Groundwater Transfer Review Summary Form

Transfer/PA # T- <u>14277</u>
GW Reviewer <u>Stacey Garrison</u> Date Review Completed: <u>12/13/2024</u>
Summary of Same Source Review:
☐ The proposed change in point of appropriation is not within the same aquifer as per OAR 690-380-2110(2).
Summary of Water Level Decline Condition Review:
☐ Water levels at the original point(s) of appropriation have exceeded the allowed decline threshold defined by conditions in the originating water right.
Summary of Injury Review:
☐ The proposed transfer will result in another, existing water right not receiving previously available water to which it is legally entitled or result in significant interference with a surface water source as pe 690-380-0100(3).
Summary of GW-SW Transfer Similarity Review:
\Box The proposed SW-GW transfer doesn't meet the definition of "similarly" as per OAR 690-380-2130.
This is only a summary. Documentation is attached and should be read thoroughly to understand the basis for determinations.

1. Basic description of the changes proposed in this transfer: The applicant proposes to replace existing and authorized "Well 1/MC 1" (MARI 13286) with to-POAs: "Well 3/Marion Count

Map

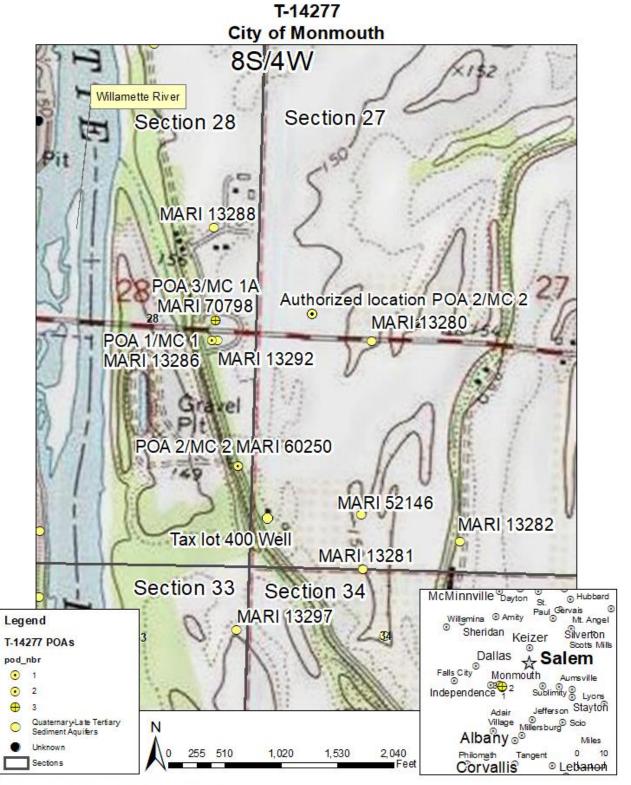
NOTE: There is a discrepancy between the mapped location of the POAs as indicated on the applicant's map and the metes-and-bounds description using the Department's PLSS projection. The mapped location is coincident with the GPS coordinates provided, and was used. The discrepancies are listed below.

- Well 1/MC 1 (MARI 13286): the metes-and-bounds location is 131 ft southeast of the location used.
- Well 3/Marion County Well #1A/MC 1A (MARI 70798): the metes-and-bounds location is 105 ft southwest of the location used.
- Well 2/MC2 (MARI 60250): the metes-and-bounds location is 426 ft northwest of the location used.
